II. RESPONSE TO OFFICE ACTION

Appl. No.: 10/089,0489 Reply to Office Action of September 23, 2004 Annotated Sheet Showing Changes

Fig. 8

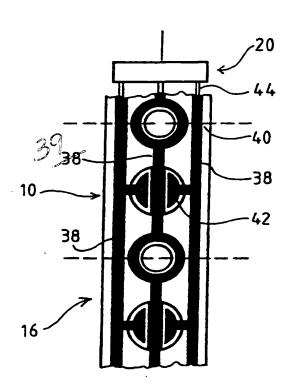
Filed concurrently herewith are corrected figures 8, 9 and 14. Specifically, in Figures 8 and 9, the central electrode track has been labeled the reference character "39" in response to the Examiner's objection to these figures. The specification has been amended accordingly.
